PREVOST

WARRANTY BULLETIN

WB15-13

DATE :	MARCH 2015	SECTION :	16 - Suspension
EXPIRATION:	MARCH 2017		
SUBJECT :	IFS LEVEL VALVE CONTROL ROD POSSIBLE CONTACT

Figure 2

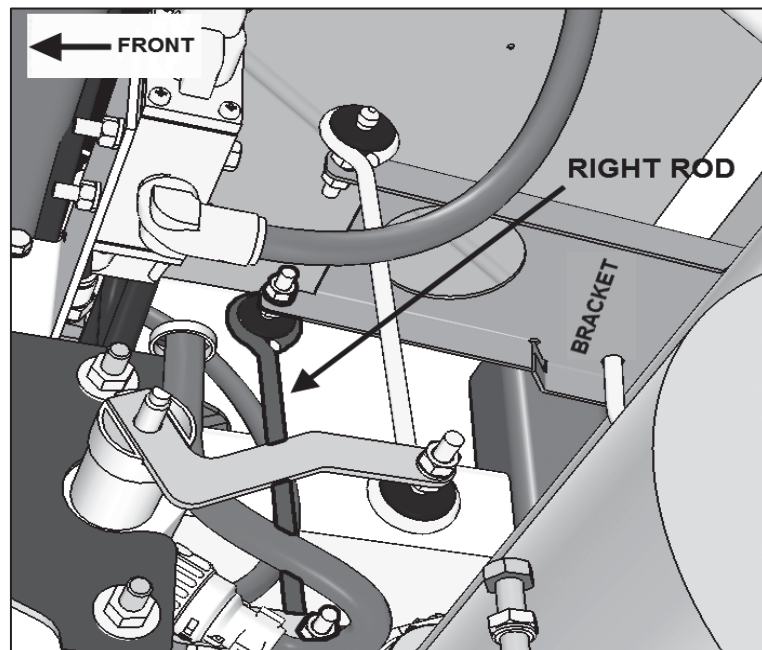
2. In the middle of the sway bar you will find a bracket clamped on the tube. The bracket supports two control rods (Fig. 2)

3. On the right hand side rod. (Fig.2) Unscrew the upper and lower mounting nuts.
4. Flip the rod over to the opposite side of the control lever and bracket tab above. (Arrow, Fig. 3)
5. Re-assemble hardware. (Fig.3)

Figure 3 : Flip upper and lower connection of control rod.

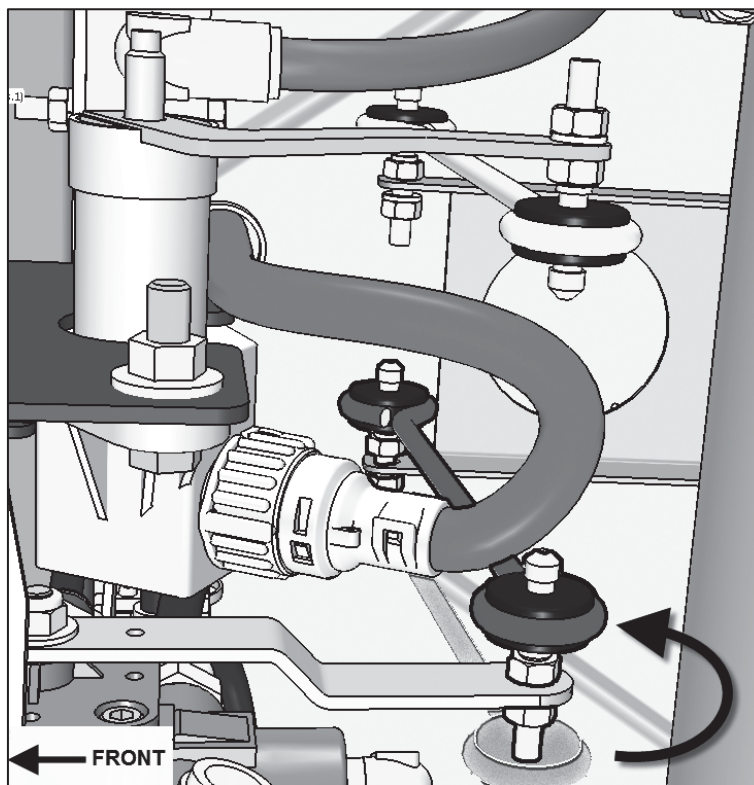
On the independent front suspension level valve linkage of the vehicles affected by this bulletin, a control rod may come in contact with an air reservoir outlet when vehicle rises from Low to High Buoy. As a result, the vehicle may be leveled higher in "Normal" position.

The interference is corrected by changing the side on which the rod is attached to the linkage.

Figure 4

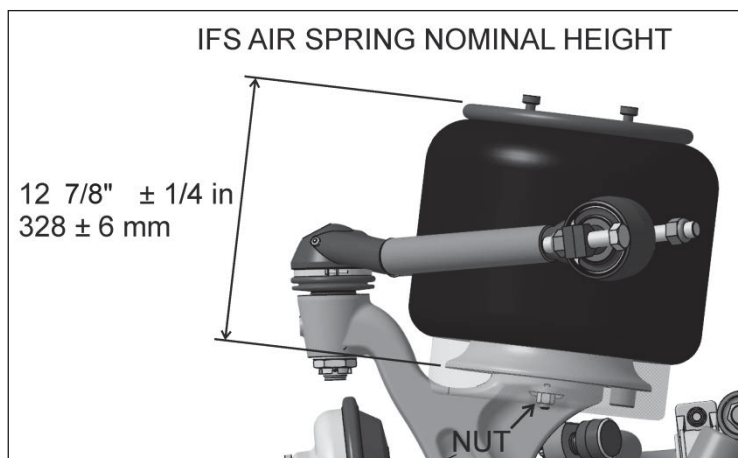
6. Adjust ride height to $12 \frac{7}{8}'' \pm 1/4''$. (328mm $\pm$ 6mm)
